**FOUR COUNTY SC LIDAR  
QUALITY ASSURANCE  
OCONEE COUNTY REVIEW**

UNITED STATES GEOLOGIC SURVEY  
AND  
SOUTH CAROLINA DEPARTMENT OF NATURAL  
RESOURCES

USGS CONTRACT: G10PC00025  
TASK ORDER G11PD01086

First review: November 15, 2011  
Second review: February 21, 2012

**Figure 2: Overall project flightline exhibit (left) and enlarged view (right)**

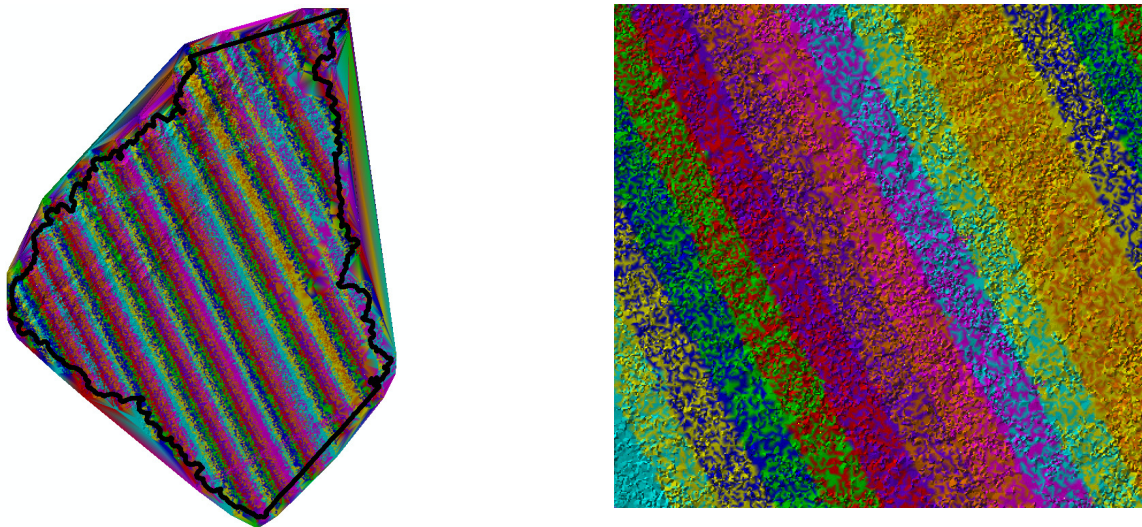
The flightlines were flown with a sidelap of 45 to 50%. The collected data couldn't have holidays and needed to have periodic and local calibration checks. No holidays were noted in the review of 10% of the project area. The exhibits below show the extents of sidelap:

**Figure 3: Oconee County Checkpoints**

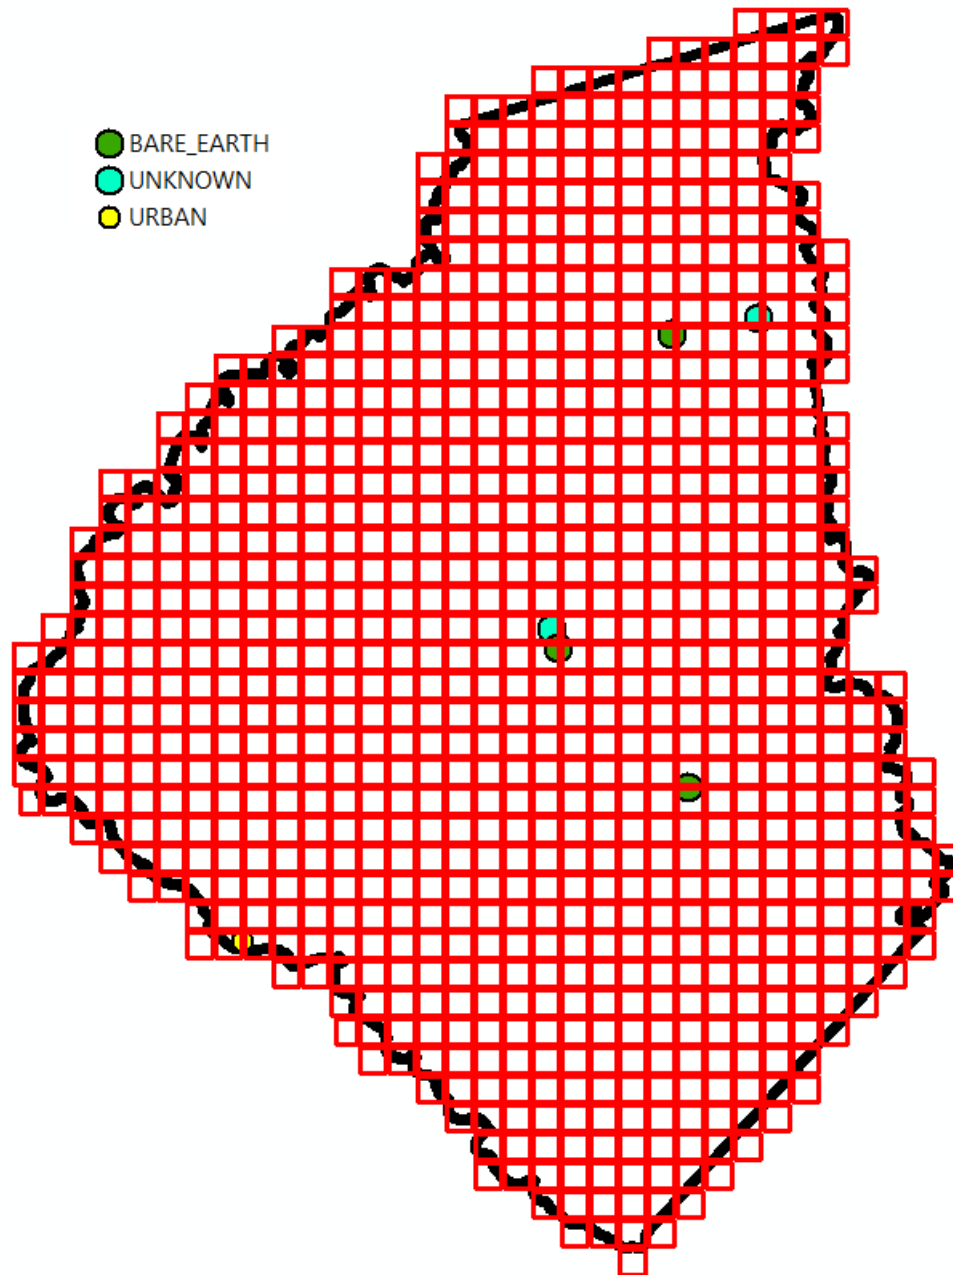
The Criteria also requires GPS baseline lengths to be less than 25 miles. The GPS baseline lengths are established by the distance between check points. Six check points were collected for the Oconee County data collection – the classification was not provided for two points, three are classified as bare earth, and five points are classified as bare earth. The figure below shows the location of said checkpoints in relation to Oconee County and the provided tiles.

**Figure 4: Forward vs. Reverse Post-Processed Solution – Lift 072B**

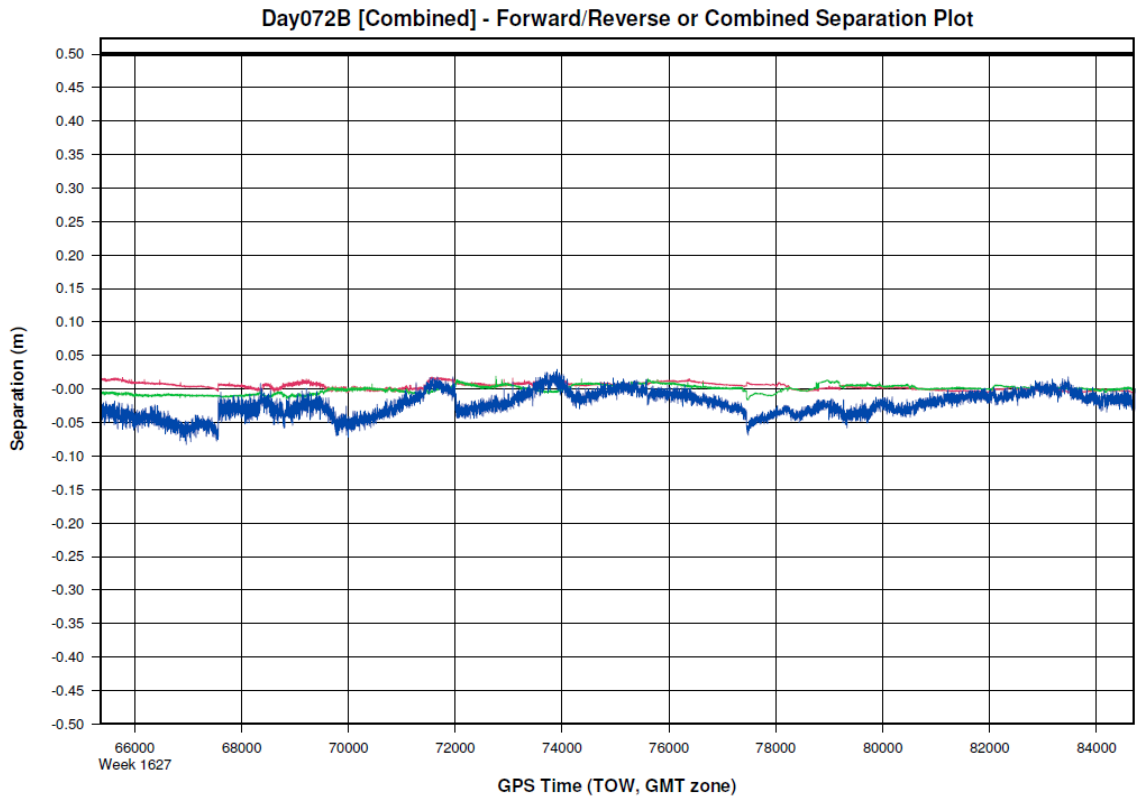
Additionally, the Criteria requires the GPS trajectories to be evaluated with forward and reverse comparisons within 10-20 cm. The GPS solution chart below, as provided by Dewberry, shows forward and reverse comparisons within 3 - 7 cm as provided in the TriCounty\_SC\_Report.pdf.
